**Economic Commission for Europe****Inland Transport Committee****World Forum for Harmonization of Vehicle Regulations****Working Party on Noise and Tyres****Seventy-ninth session**

**UN Regulation No. 138 (Quiet road transport vehicles)****Proposal for a new series of amendments to UN Regulation  
No. 138****Submitted by the experts from the Task Force on Quiet Road  
Transport Vehicles\***

The text reproduced below was prepared by the experts from the Task Force on Quiet Road Transport Vehicles (TF QRTV) in order to specify the working principles of an Acoustic Vehicle Alerting System (AVAS), to improve road safety and to reduce measurement uncertainties during the measurement of the one third octave bands. The modifications to the existing text of the UN Regulation are marked in bold for new or strikethrough for deleted characters.

Figures 2a and 2b  
**Measuring positions for vehicles in motion indoor and in standstill**  
**additional 2 microphones needed at the front and in the back in 2 m distance**

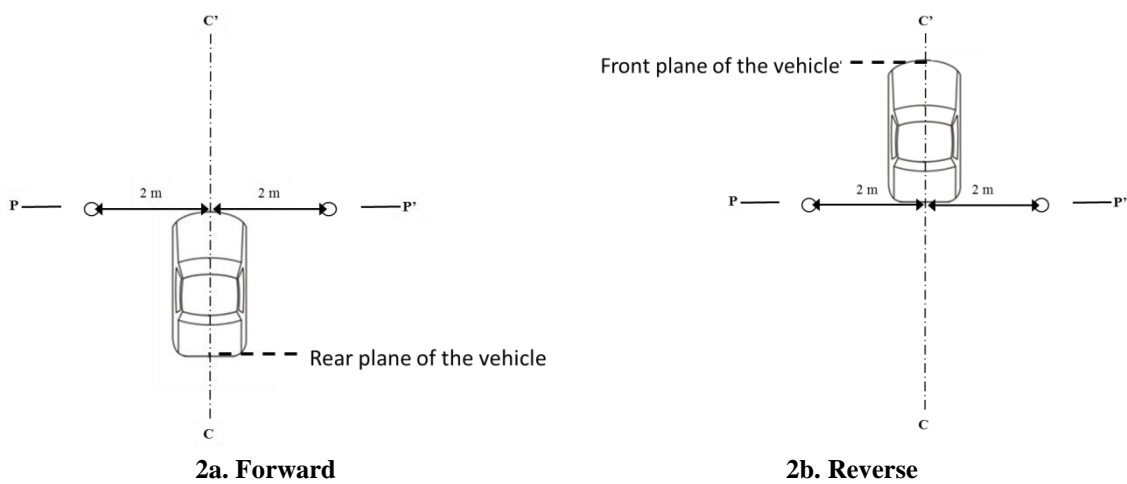
**In case of measurement Method (B), (C) and (D) the microphones have to be located on the front and rear plane of the vehicle (see Figure 2a and 2b).**

**For the measurements of the opposite side of driving direction at method "B", "C", "D" additional microphones are necessary (see figure 2a , 2b).**

Figure 5  
~~Vehicle A-Weighted sound pressure level measurement correction criteria~~  
Background noise requirements

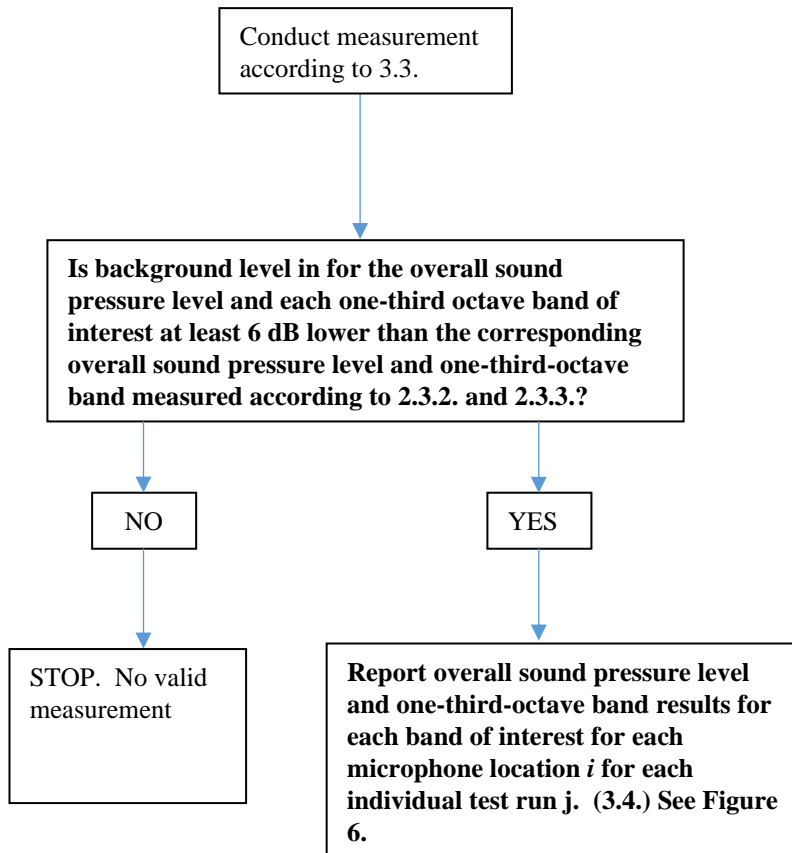
As an aid for measurement correction criteria see flowchart in Figure 5 of the appendix to this annex.

**Test procedures for measurement of frequency shift** (~~method E deleted; method A ?~~)

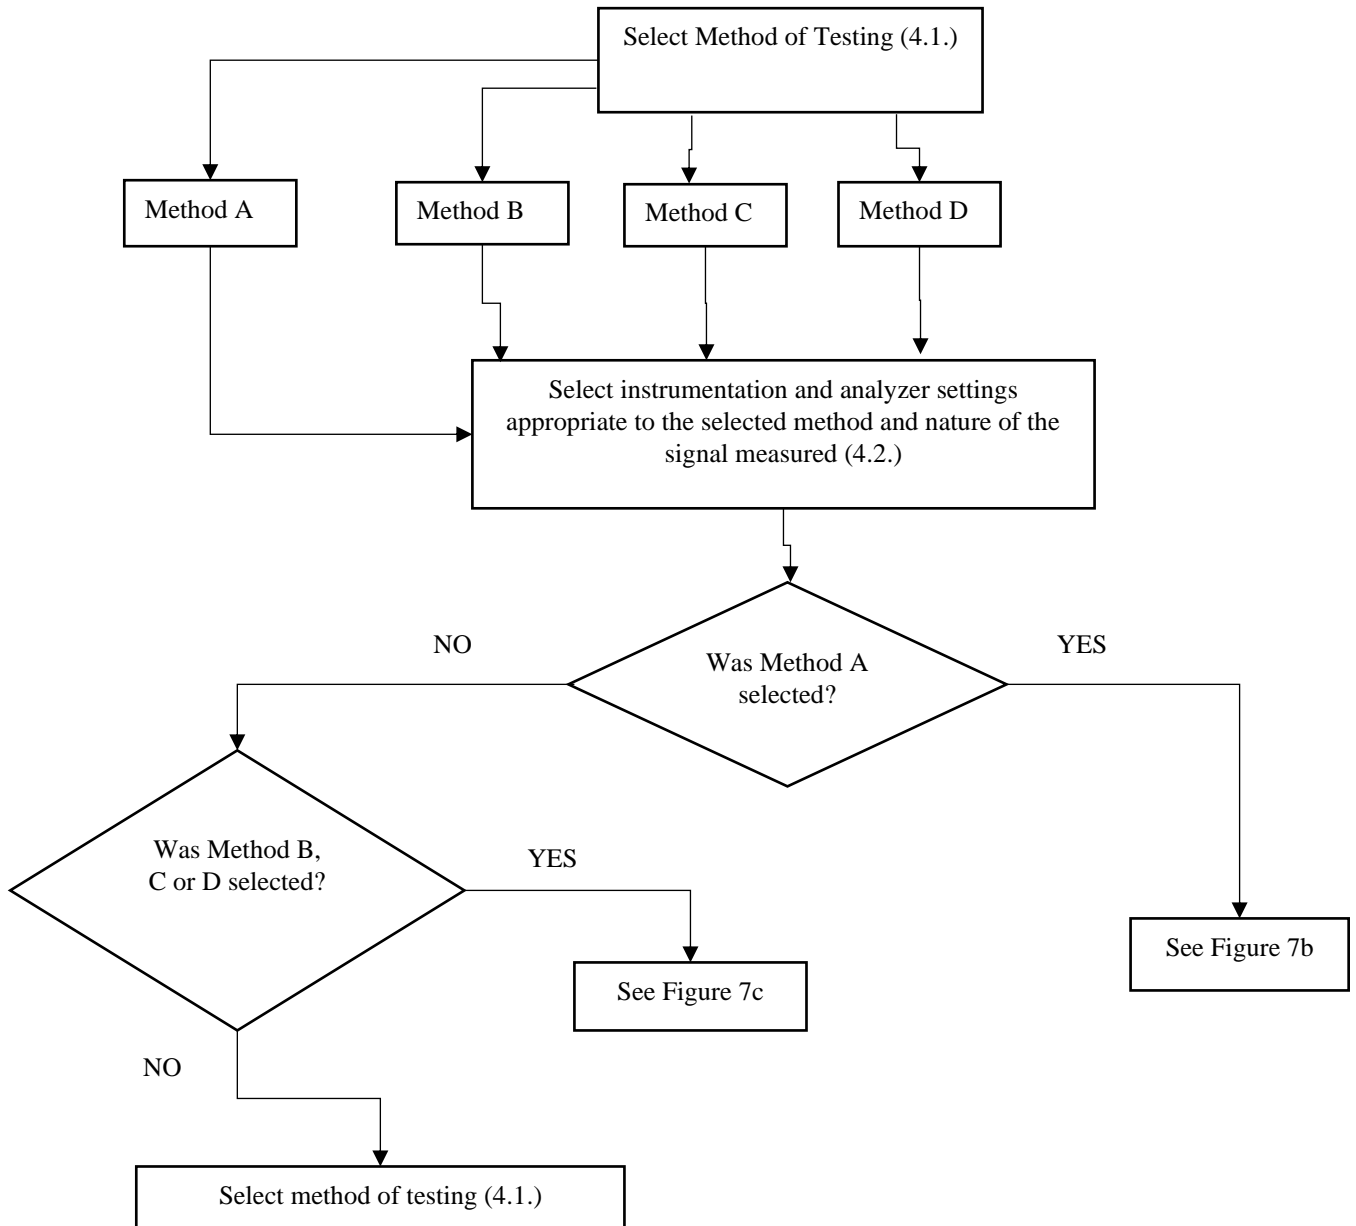
\* Note by the secretariat: as an aid for measurement of frequency shift see flowchart in Figure ~~67a, 67b~~ or ~~67c~~ of the Appendix to this annex.
